June 13, 2005

The Case Against A Proposed Relaxation Of Out-Of-Band Noise And Spurious Specifications For DOCSIS Edge-QAM RF Devices

Submitted by Broadband Innovations, Inc.

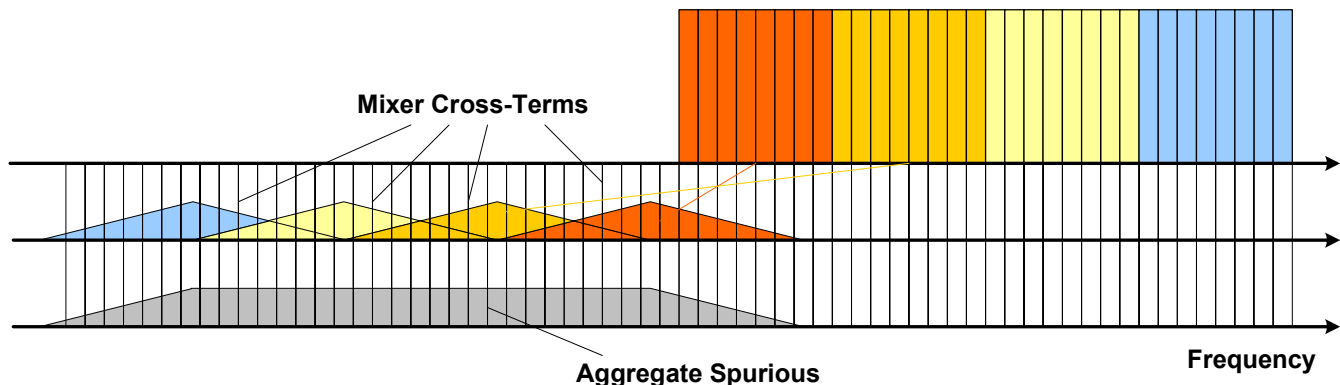
Returning to Figure 1, it shows a disturbing trend for the future if Items 5(d) and 8 remain: As the number of channels in a QAM block increases, permitting these mixer cross terms to reach the levels in Item 8, would result in wide -63 dBc spurious noise plateau on other channels. In fact, contrary to notions advanced by the JPSA proponents, the total self-aggregating specifications of Item 7 *does not* limit the number of channels in such -63 dBc plateaus because Item 7 is set for -55 dBc and because the permitted -63 dBc aggregate limit in Item 8 *does not* include all spurious and noise power. It should be noted that because over the tuning range, there is no escape from a condition in which these mixer terms fall immediately near the desired channels, allowance of these mixer cross-terms to reach levels of -63 dBc would necessarily also require relaxation of the third adjacent channel specifications. Therefore, look for the JPSA proponents' future attempts to expand the relaxation of item 5(d) into the third adjacent channel. Clearly, if the exemptions in Item 5(d) of the JPSA specifications were to be adopted, operators would have insufficient protection from the adverse effects of these modulated mixer spurious components - *not even the protection they enjoy today under the current DOCSIS RFI*. Thus, the JPSA exemption is a step back to inferior protection and a regression in specifications¹.

Figure 2. Cross-Type aggregation of second order mixer spurious components from 7 upconverter types having distinct 2nd IF frequencies that are tuned to distinct channels shown by the colored circles on the horizontal axis.

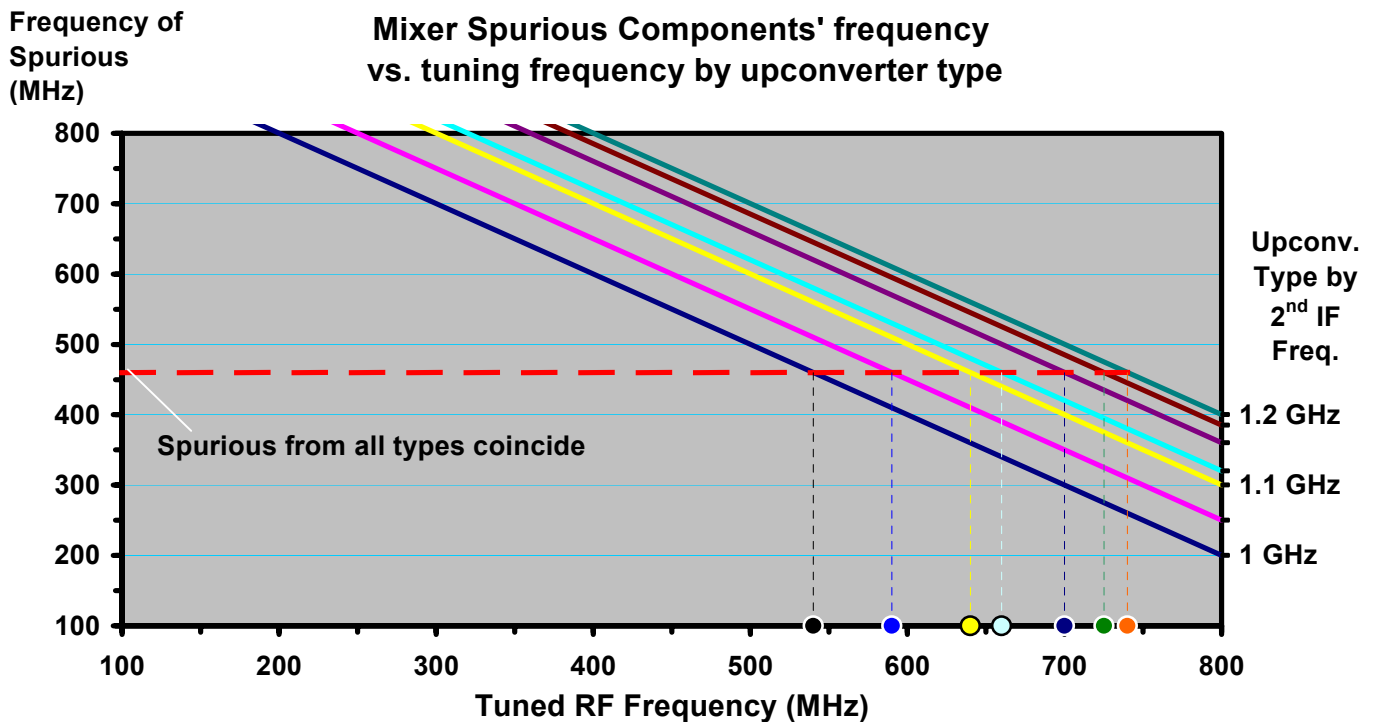
operator's risk. Suffice it to say that this example demonstrates that no matter how many distinct types of upconverters are employed, *it is certain* that one can always find *many* tuning configurations for which the spurious components from *all* such upconverter types are aligned, realizing the worst-case aggregation conditions.
